PLANNING CLEARANCE
(multifamily and non-residential remodels and change of use)
Grand Junction Community Development Department

TAX SCHEDULE NO. 2945-262-05-001
 CURRENT FAIR MARKET VALUE OF STRUCTURE \$ 25,480
 ESTIMATED REMODELING COST \$ 10,000.00
 NO. OF DWELLING UNITS: BEFORE — AFTER —
 CONSTRUCTION
 USE OF ALL EXISTING BLDGS restaurant/bar
 DESCRIPTION OF WORK & INTENDED USE:
interior upgrade -
becoming restaurant
only - no liquor

**Survey For
WILLIAM WALDEN
LOT 1 & E 1/2 LOT 2
BLOCK 5
FAIRLEY ADDITION**

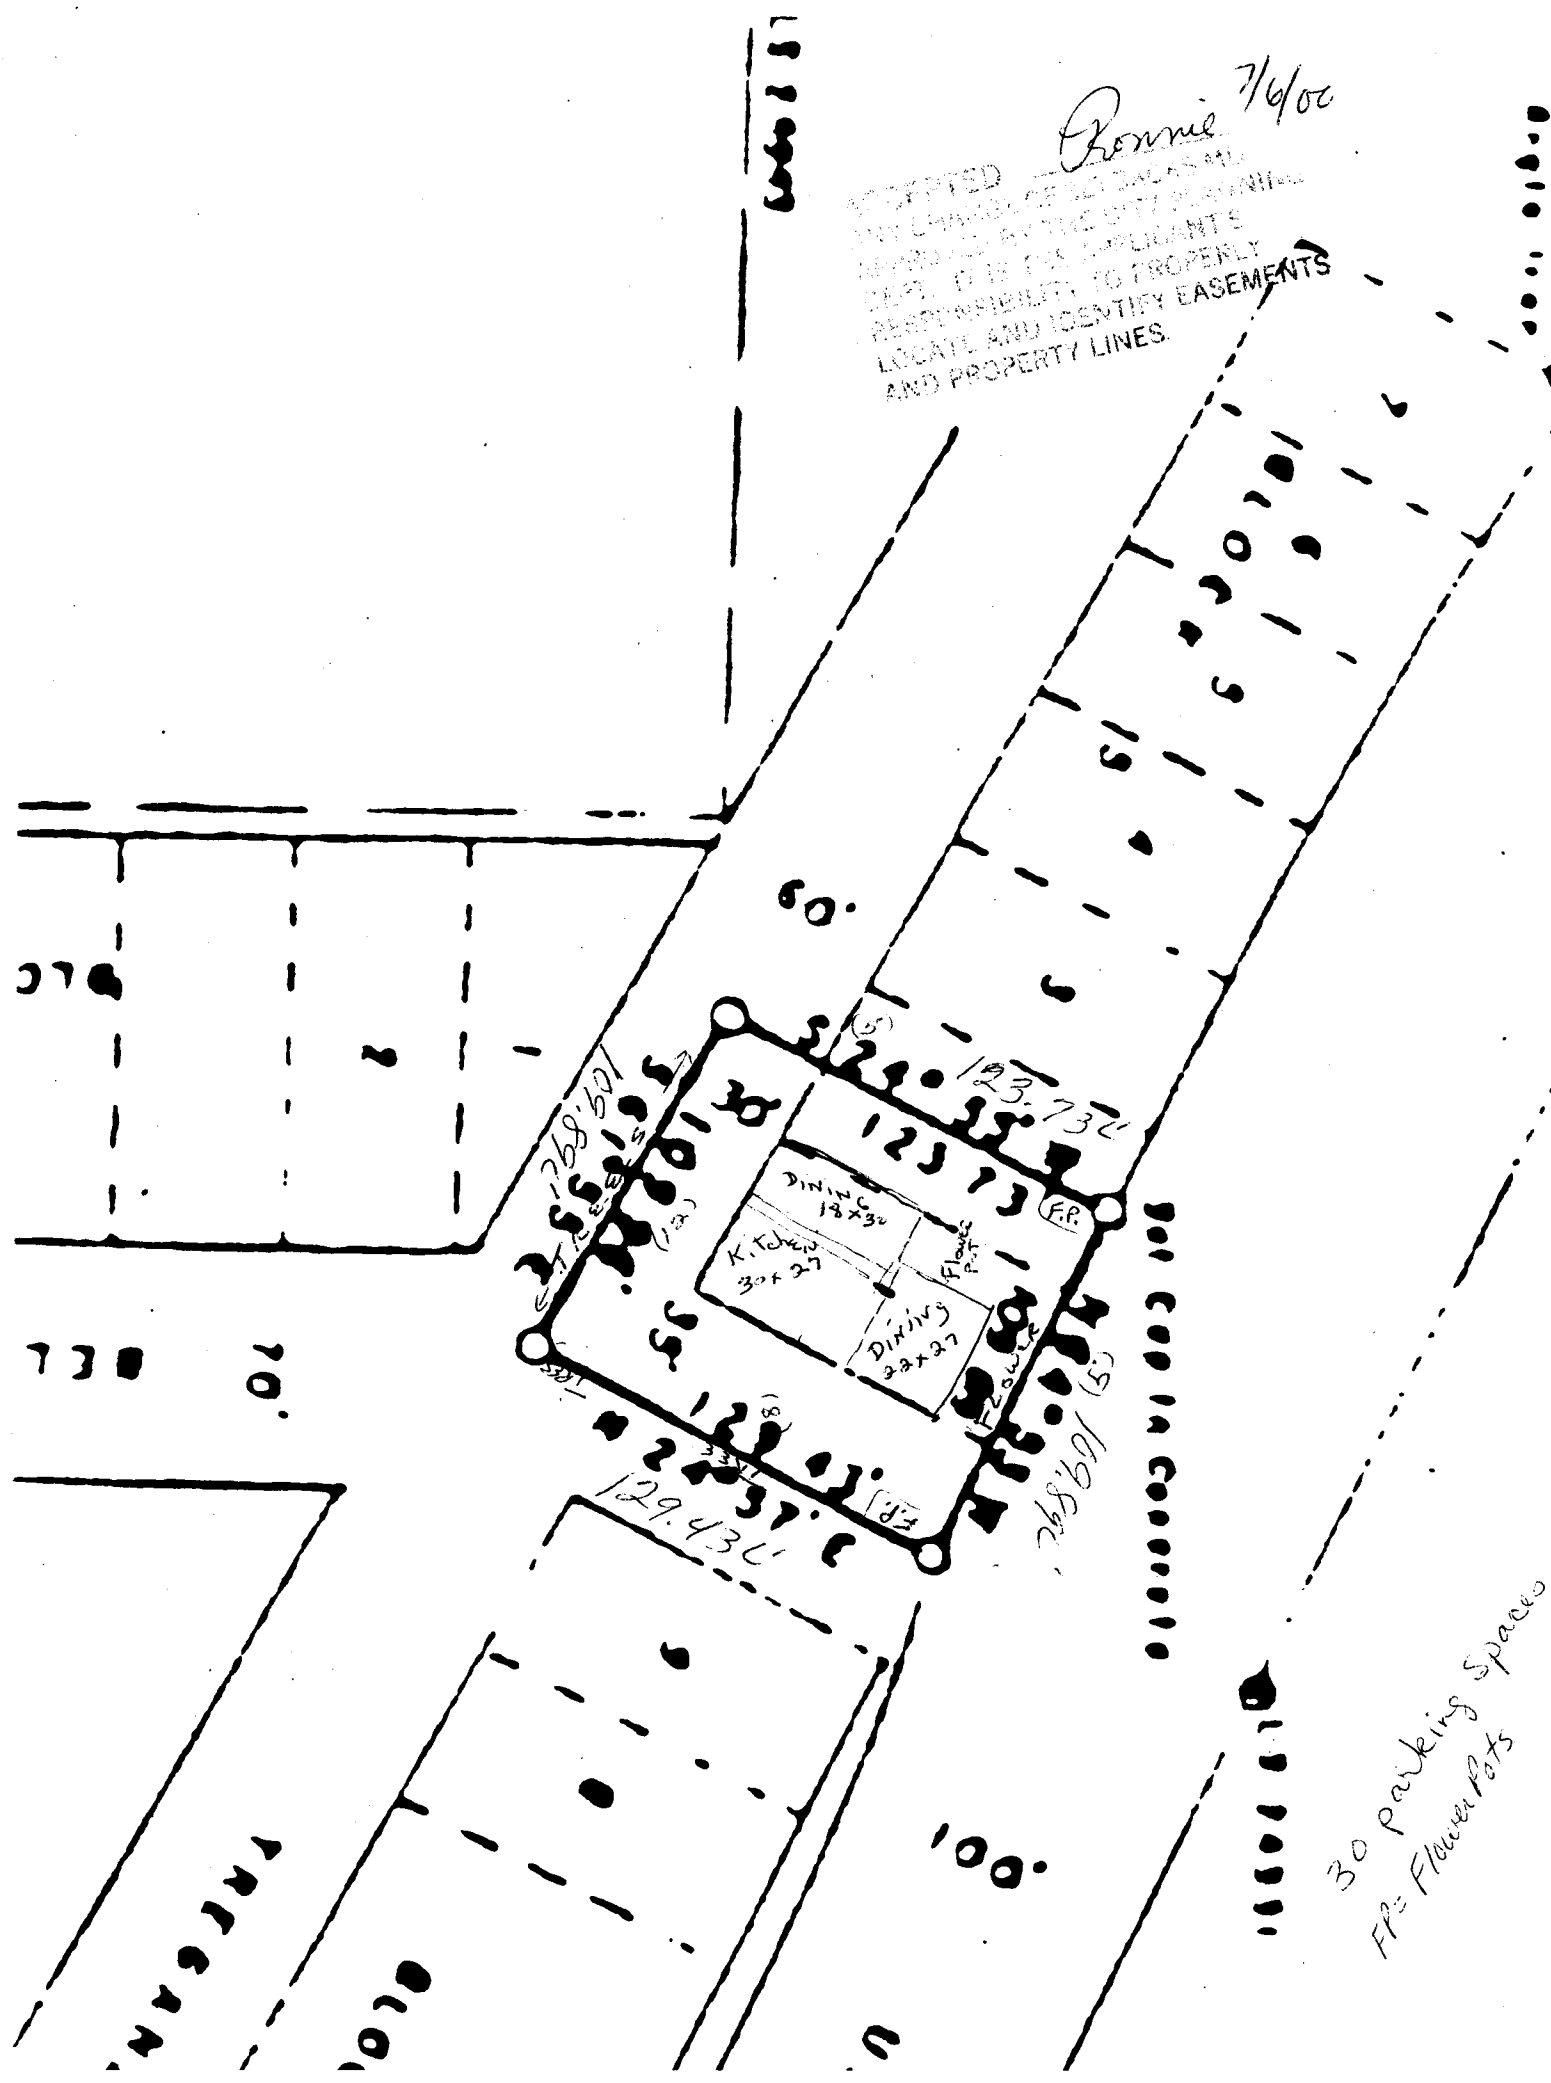
ACCEPTED *Bonnie* 7/6/00
ANY CHANGE OF SETBACKS MUST BE
APPROVED BY THE CITY PLANNING
DEPT. IT IS THE APPLICANT'S
RESPONSIBILITY TO PROPERLY
LOCATE AND IDENTIFY EASEMENTS
AND PROPERTY LINES.
